PRINCE OF WALES DR. DEVELOPMENT

Railway Proximity
Assessment Review

SYSTRA Canada Reference: 24619-10-GETN-0001_A

VIA Rail Canada

Figure 3-2: FCM/RAC's Standard Noise Mitigation Measure

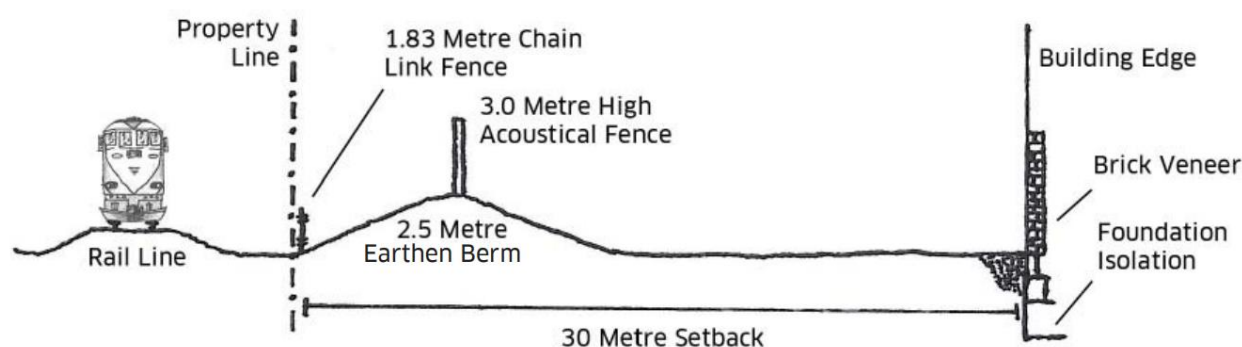
For a standard noise mitigation, FCM/RAC's Guidelines for New Development in Proximity to Railway Operations recommends a 3-m-high acoustical fence installed on a 2.5-m-tall earthen berm for building having 30-metre set-back from the right-of-way (ROW) line.

Generally, noise barriers provide significant noise reductions only when they block the line of sight between the noise source and the receiver.

Figure 3-5: Receptor's Line of Sight

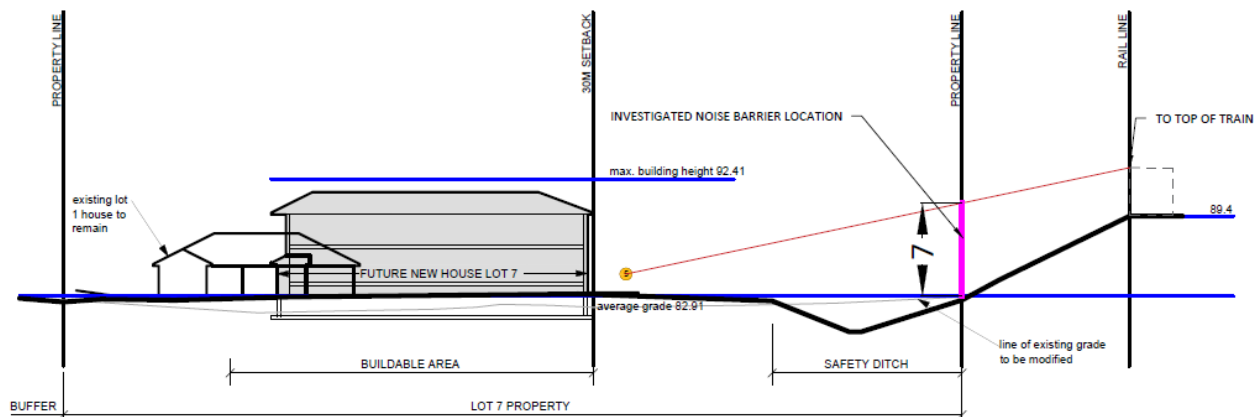
Since the railway track is approximately 6.5 m above the study site's average grade, it was determined by the Transportation Noise and Vibration Assessment that the implementation of a noise barrier is not considered technically, economically, and administratively feasible for the lots backing onto the VIA Rail corridor, and a Warning Clause will be required in all Lease, Purchase and Sale Agreements.
